IREDELL COUNTY HEALTH DEPARTMENT

IMPROVEMENT PERMIT / AUTHORIZATION TO CONSTRUCT / OPERATION PERMIT / EXISTING SYSTEM

Reference: **Technical Assistance with Fast Track Septic Permitting**
Lot 16 Bay Crossing Subdivision
Iredell County, North Carolina
S&ME, Inc. Project No. 4358-14-086

Bay Crossing Lot 16 Fast Track System Information

SOIL/SITE EVALUATION
for ON-SITE WASTEWATER SYSTEM

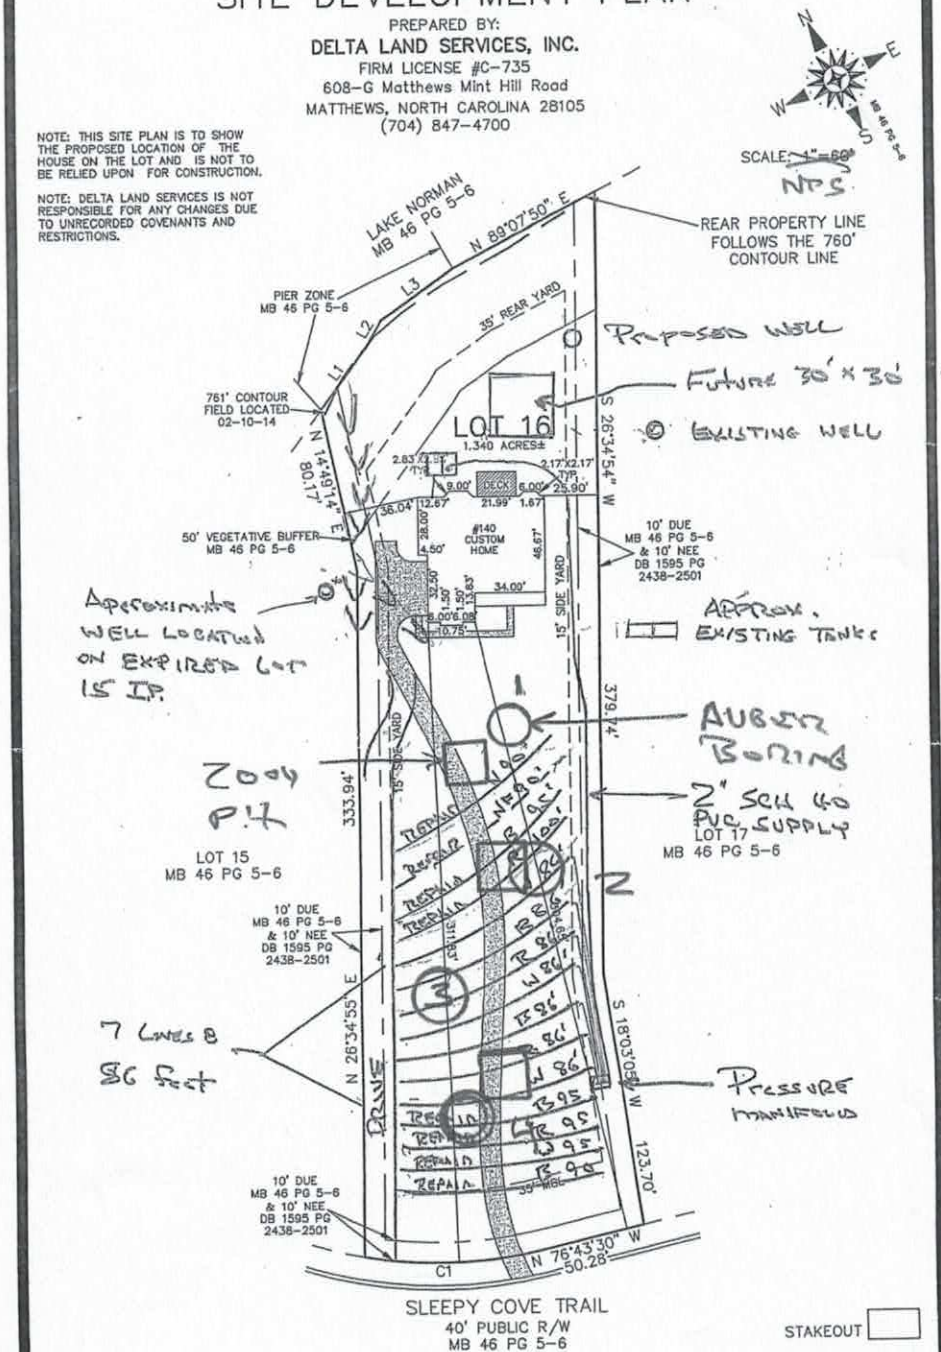
COMMENTS: Use 18" TB if well setback C 100'

SITE DEVELOPMENT PLAN

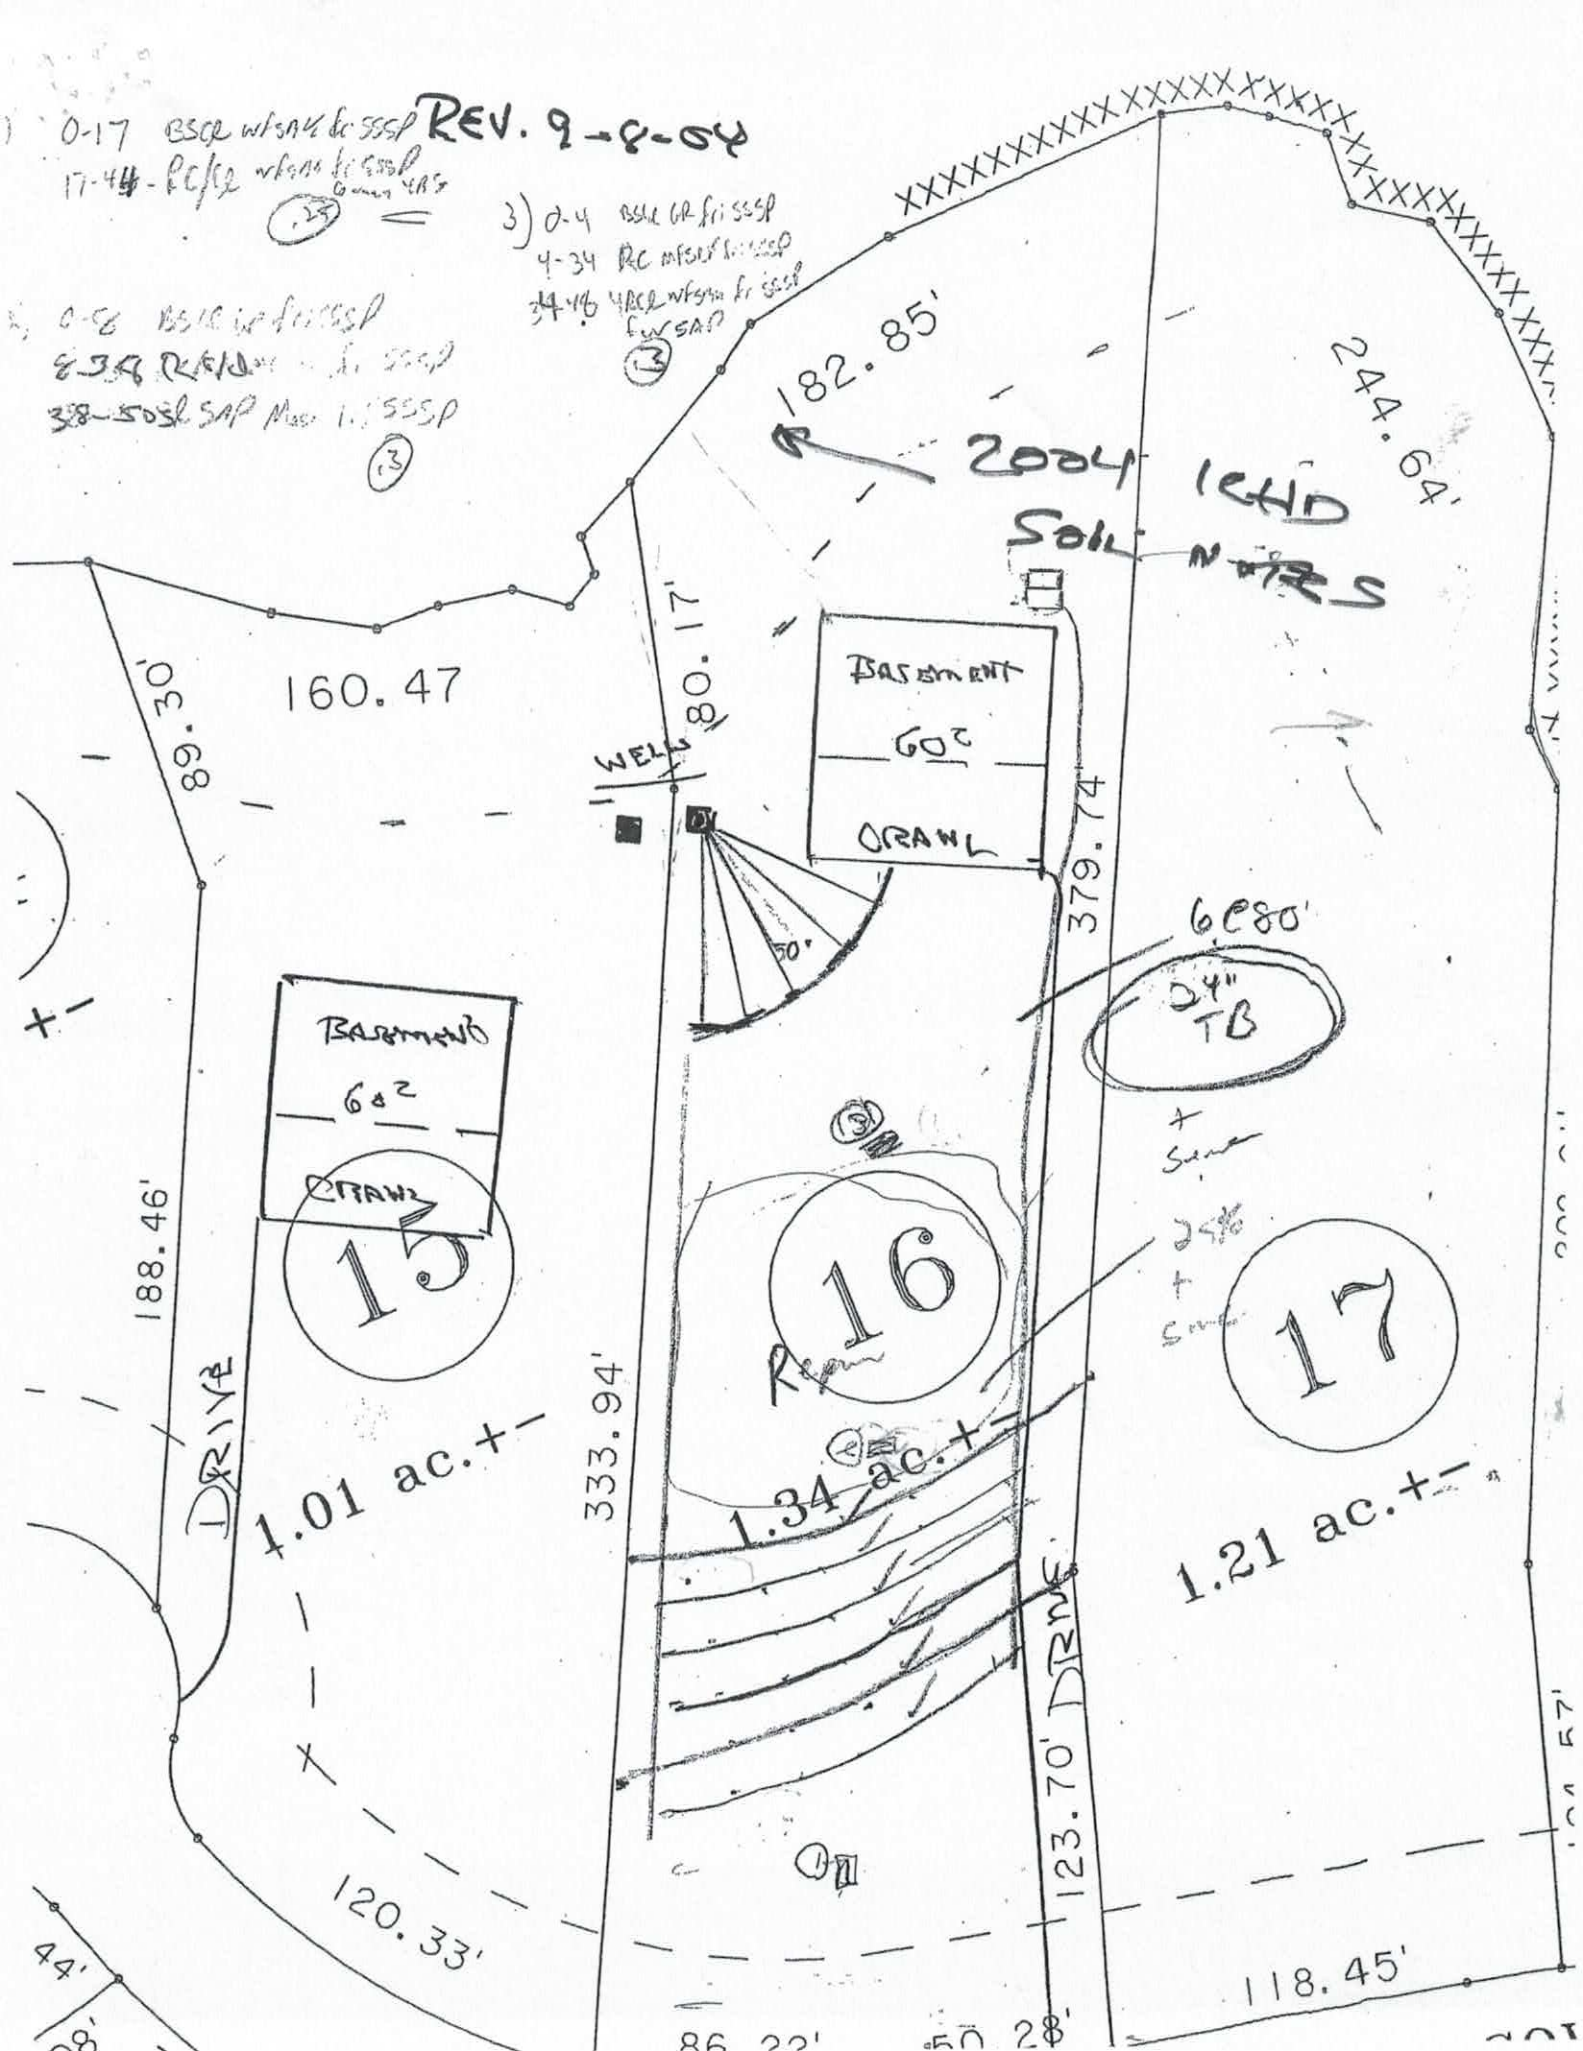
> Paul,
>
> As we discussed on the phone, the pool will be removed from the site plan and the tanks will be placed behind the house, no closer than 50' to the well. The drain field will need to be a max of 18" deep to avoid saprolite. I've noted the changes on the site plan and changed the max trench bottom depth on the permit.
>
> Thanks,
>
> Ben Aldridge, REHS
> Iredell County
> On Site Waste Water
> Private Water Wells
> 704-660-3632

I am OK with you changing our fast track plan for the new house as long as the permit meet all the rule and ICHD requirements. Paul

DRAWING TITLE: NEW LOWER LEVEL PLAN

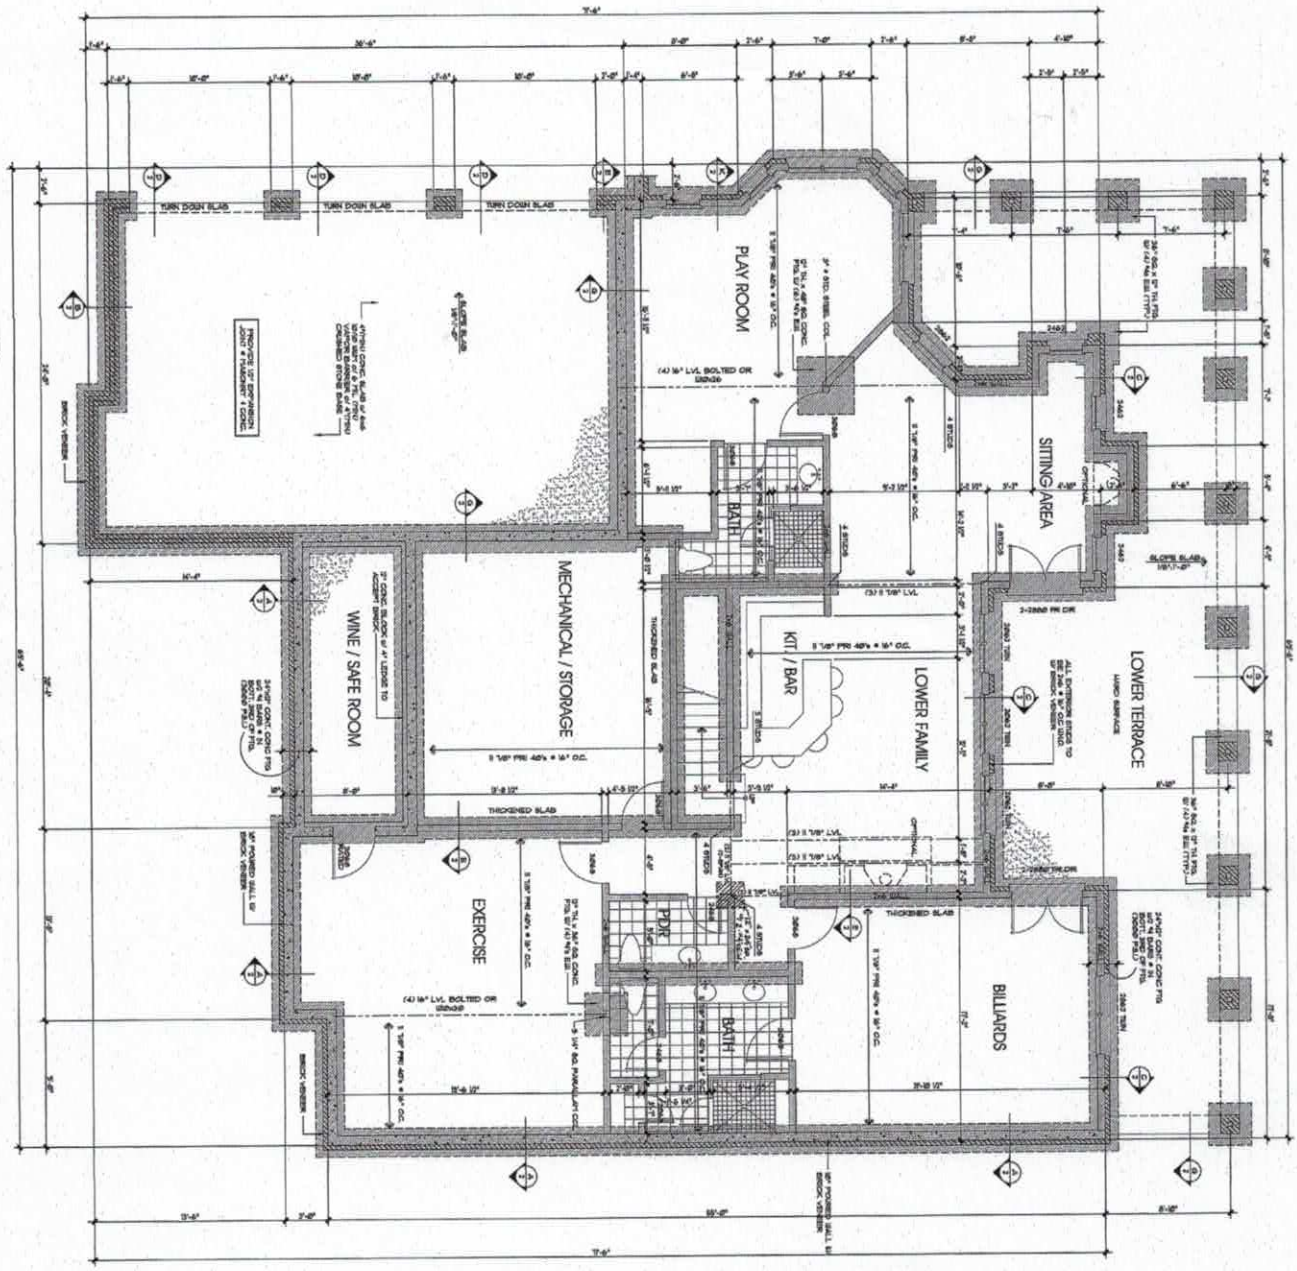
Acknowledgement of
Plans Submittal ONLY!

Date APPROVED JUL 22 2015
